CONSTRUCTION SUMMARY

Mountainview Heights 3 (G) - Russell Gardens Building Ltd.

LOT / PHASE 251 / 3	REG. PLAN # 62M-1266	HOUSE TYPE Valleycreek Four Elev 1	
------------------------	-------------------------	---------------------------------------	--

Walk-up
Larger Basement Windows

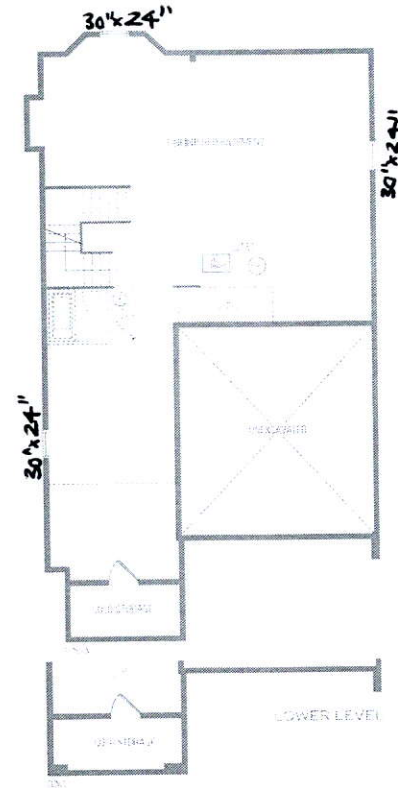
1 - MASTER ENSUITE – FRAMELESS GLASS SHOWER ENCLOSURE – INCLUDES CHROME KNOB AND HINGES 12Aug20 Note: IF CONSTRUCTION PERMITS	
3 - ENLARGE BASEMENT WINDOWS (MAY REQUIRE WINDOW WELLS) - WINDOW IS 30 INCHES X 24 INCHES 12Aug20 Note: IF CONSTRUCTION PERMITS

200 AMP

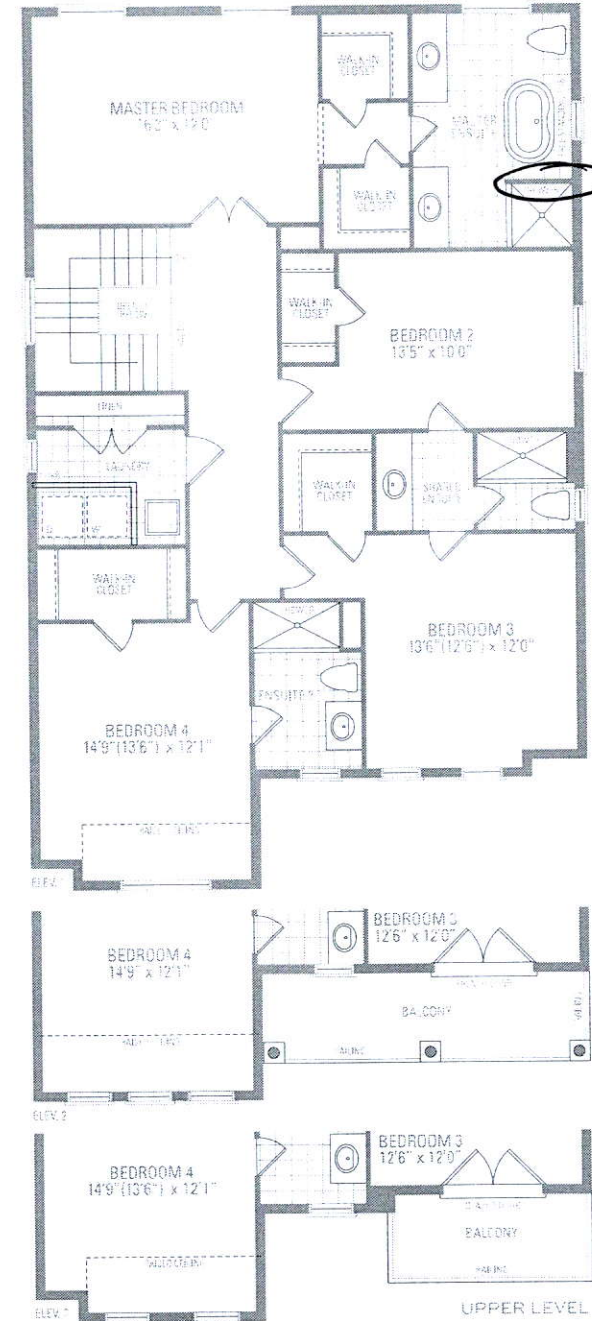
1 - 200 AMP ELECTRICAL SERVICE 12Aug20 Note:	
---	--
